March 30, 2023

**SUBJECT: NEW VEHICLE DEMONSTRATION / DELIVERY HOLD
Compliance Recall 23C02
Certain 2023 Model Year Transit
Wiring Harness Missing Jumper Loop**

SUBJECT: FSA 23C02 HVAC Function Validation

FIGURE 28

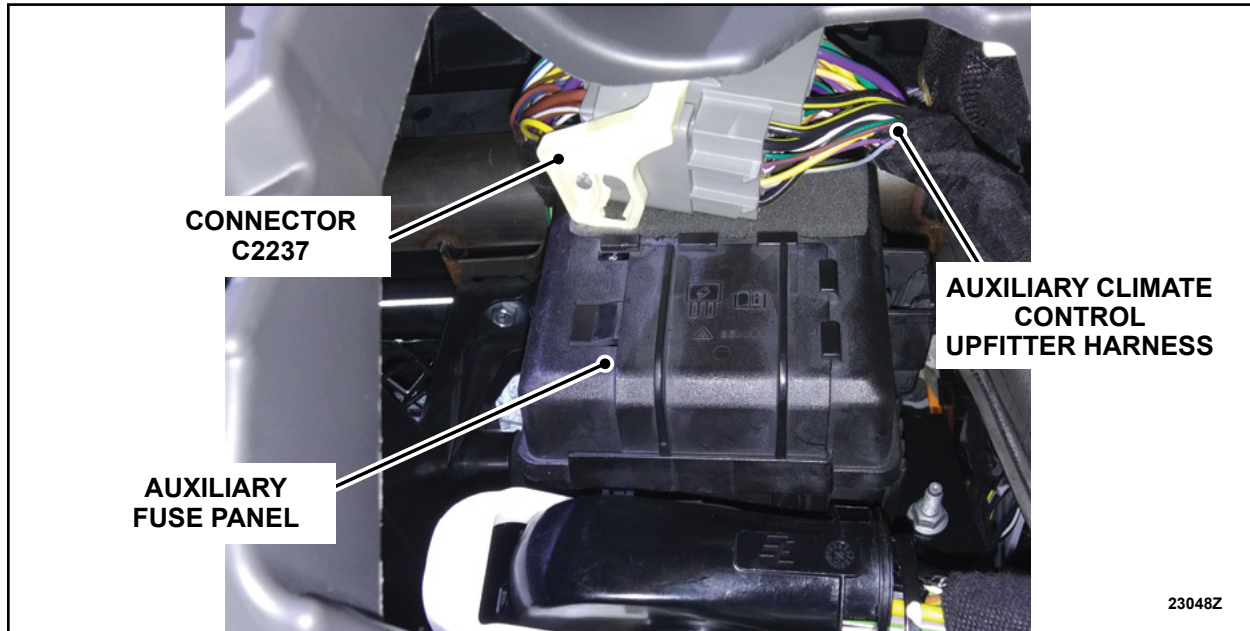
32. Route the auxiliary climate control upfitter harness back into position. Connect the harness back to connector C2237 and secure the locking latch. Then re-attach the harness to the slot on the auxiliary fuse panel. See Figure 28.

NOTE: Make sure the harness is still routed towards the firewall, making sure that it will not come into contact with any moving components or sharp edges.
